# Memorandum

**Subject** **Network Compliance Bulletin #17** (Pits in Footpaths)

**Non Compliant Installation of a Service Pit (within the footpath expansion joint)**

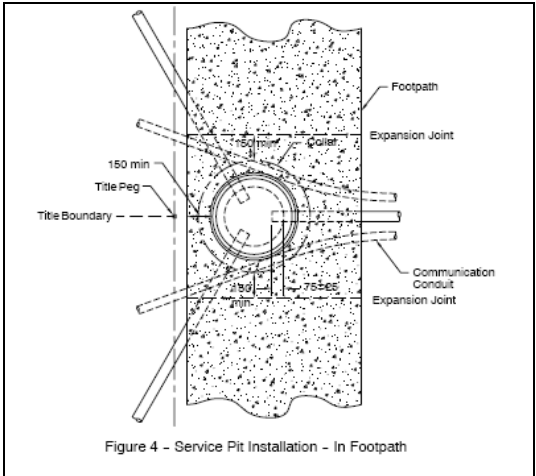
Attached is a photo of a non complying situation in a project that was recently constructed, there have also been other recent similar situations.

**Compliant Installation of a Service Pit (minimum 150mm from any edge of the footpath including expansion joints)**  
Extract from Technical Standard GS021
